Record of Decision Amendment
NM Glens Falls – Mohican Street
Former MGP Site
Operable Unit No. 1
State Superfund Project
Glens Falls, Warren County, New York
Site Number 557016

March 2010

RECORD OF DECISION AMENDMENT

Glens Falls / Warren County/ Registry No. 557016

NYSDEC
Operable Unit 1
Boundary
NIMO Glens Falls -
Mohican Street
Former MGP Site
FIGURE 2

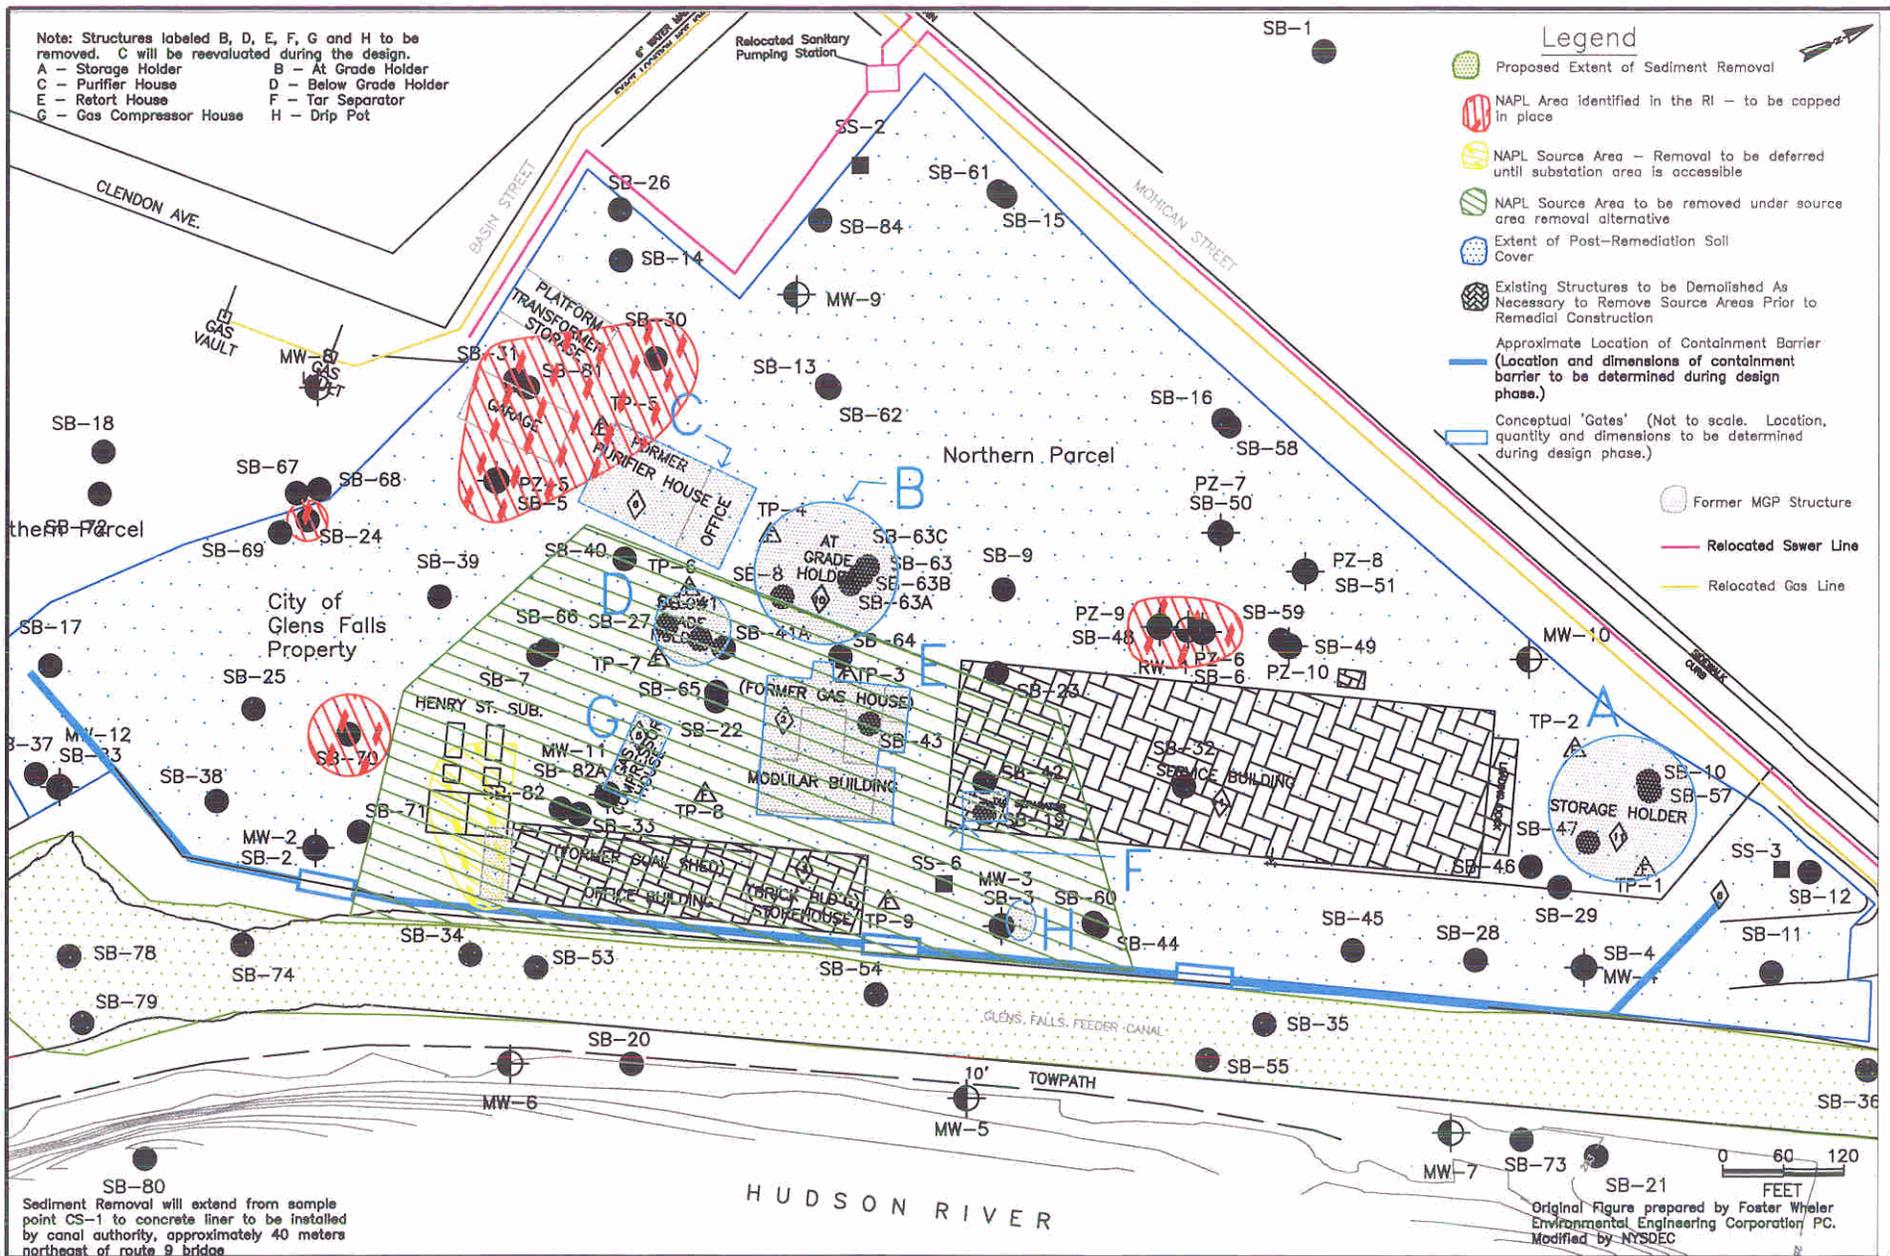
Comment 12: Will any homes be affected during construction?

Response 12: Construction will be performed within the Operable Unit 1 boundary depicted on Figure 2 of the 2010 ROD Amendment. No homes are located within the boundary.

Figure 3

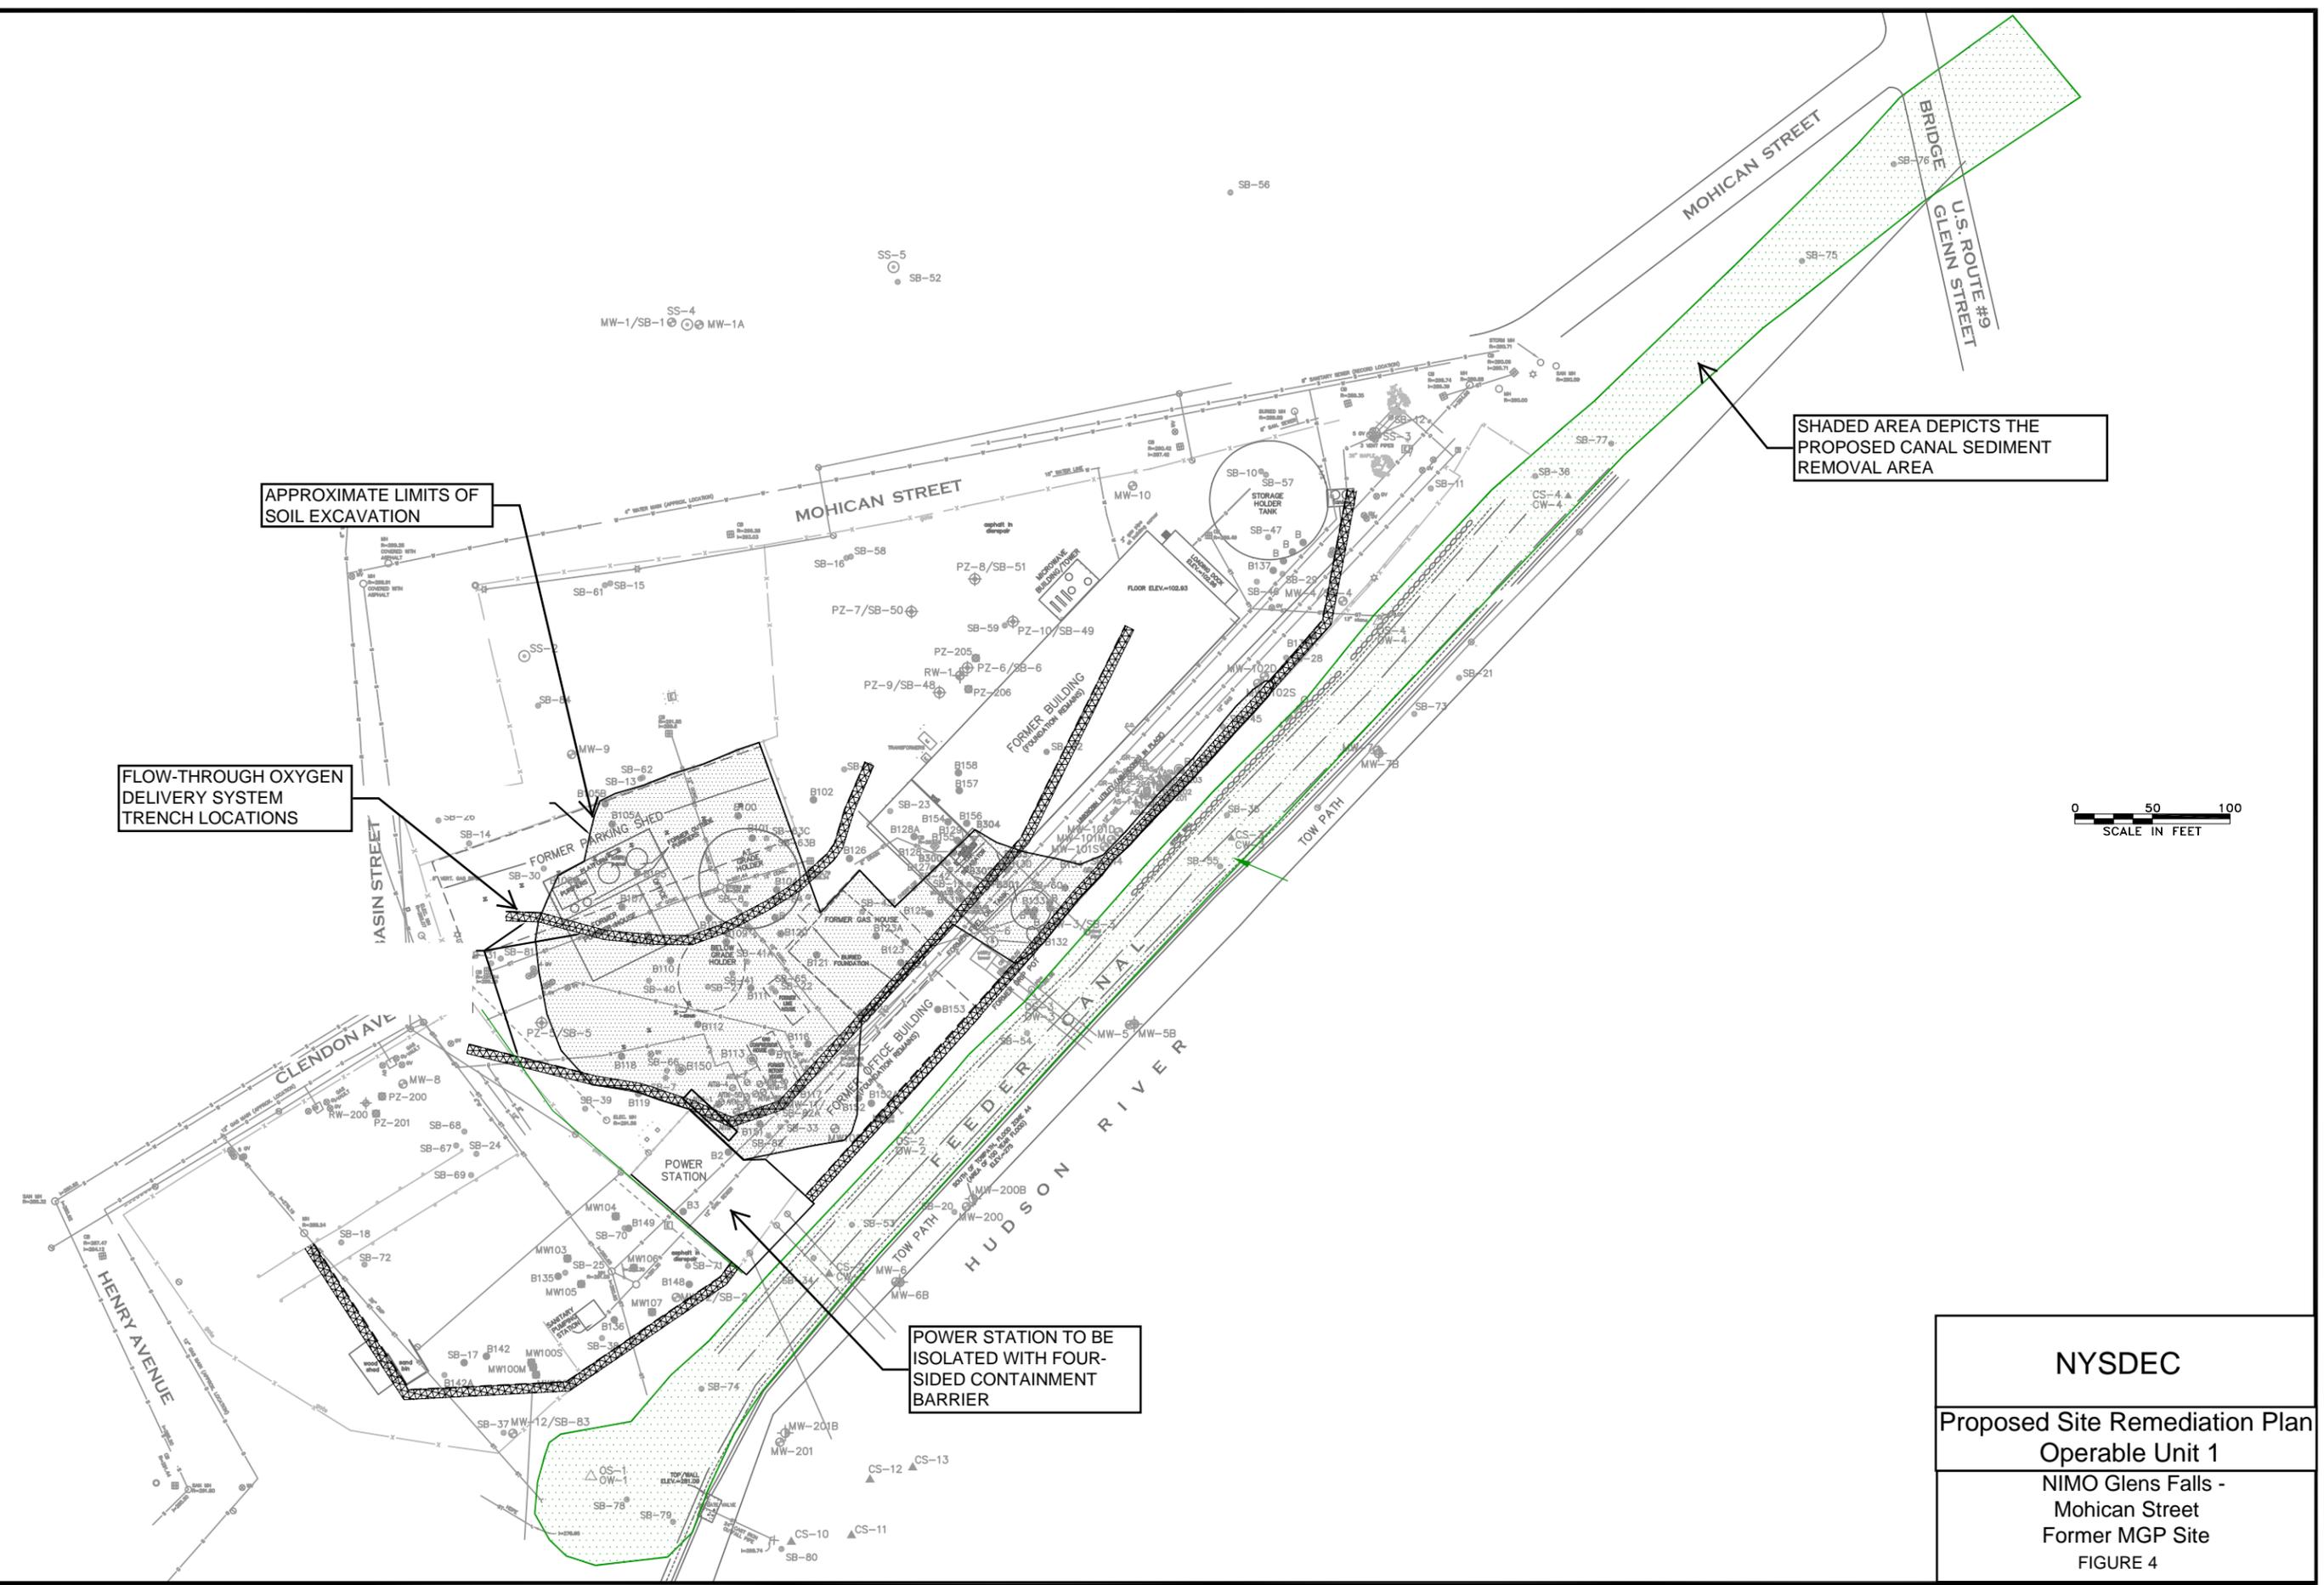
Comment 22: Figure 3 in the proposed ROD amendment indicates that the "Extent of the Post-Remediation Soil Cover" will extend to a paved area that is used by the Glens Falls Hospital for parking (located near the intersection of Basin Street and Mohican Street). As such, the ROD, the proposed ROD amendment and the conceptual design prepared for National Grid in December 2008 did not include any excavation (or other intrusive remediation activities) within this paved parking lot. Since this area will not be disturbed and is currently paved, we request that the proposed ROD amendment be

revised to indicate that a soil cover is not required at this location.

The requirement of a soil cover is appropriate in this location since the investigation results indicated elevated PID measurements from soil samples collected in this area, while other soil samples were observed to have staining and odors attributed to residual coal tar. Therefore the ROD Amendment will not be revised to eliminate the soil cover in this area, rather the current paving will satisfy this requirement as stated in the amendment. The ROD provides for the use of paved areas as a component of the soil cover, therefore the existing blacktop is the cover system in this area of the site.
